TRANS/WP.29/752  
8 December 2000

World Forum for Harmonization of Vehicle Regulations (WP.29)

**DRAFT O3 SERIES OF AMENDMENTS TO REGULATION No. 49**

(Emissions of C.I., NG and P.I. (LPG) engines)

Figure 2: Conformity of production testing scheme"

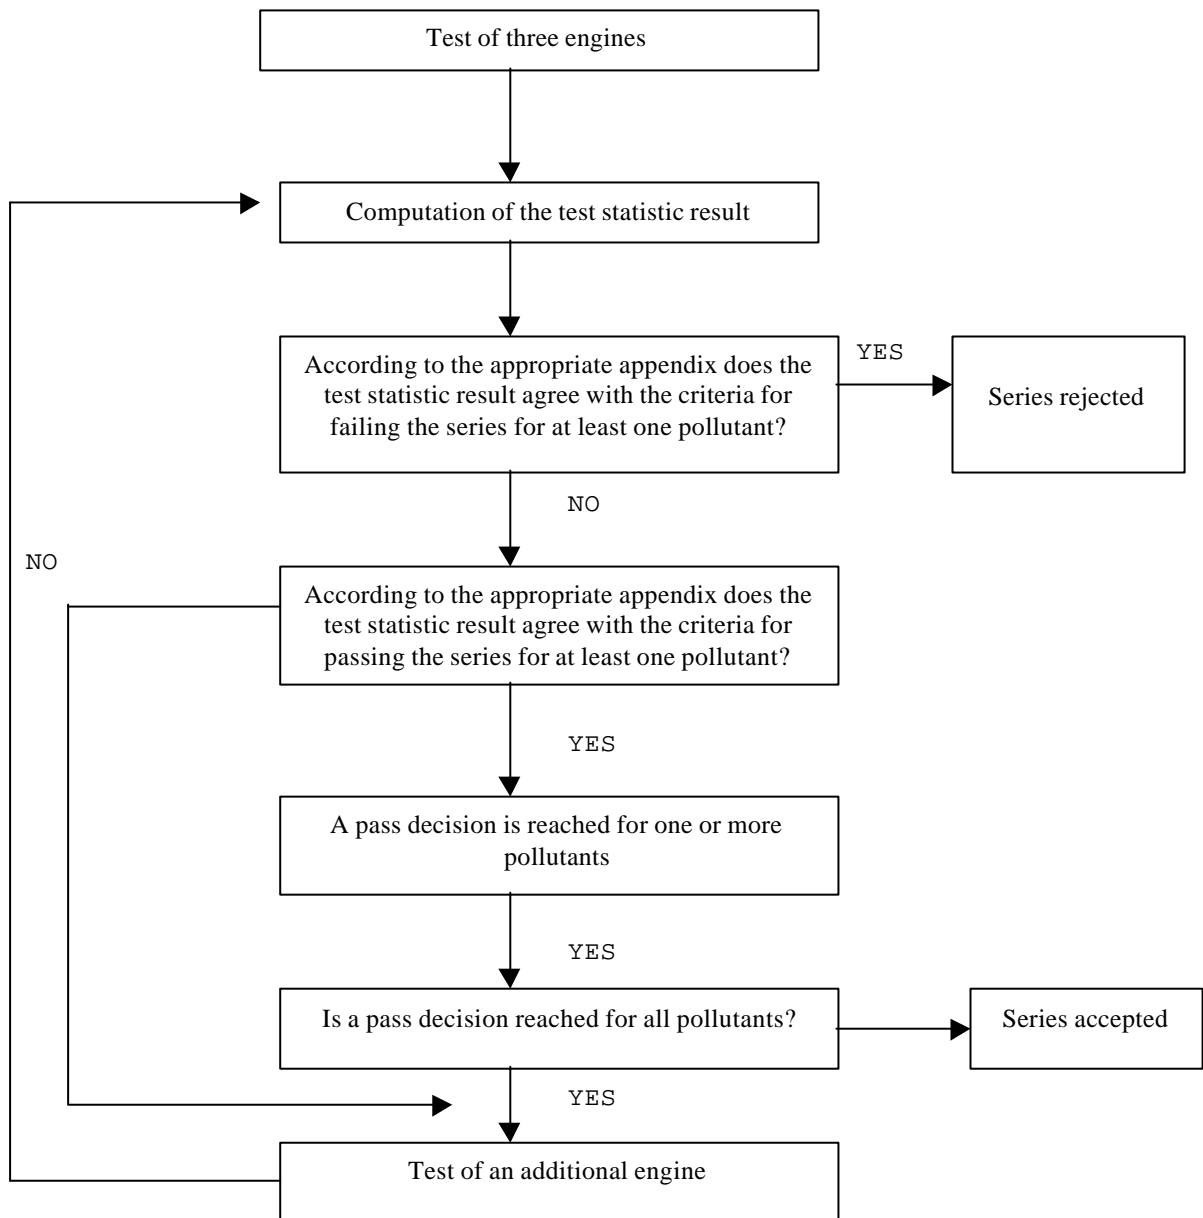
Paragraphs 7. to 7.4.4., replace by the following text (paragraphs 8. to 8.3.2.6., including also new Figure 2):

If no pass decision is reached for all the pollutants and if no fail decision is reached for one pollutant, a test is carried out on another engine (see figure 2).
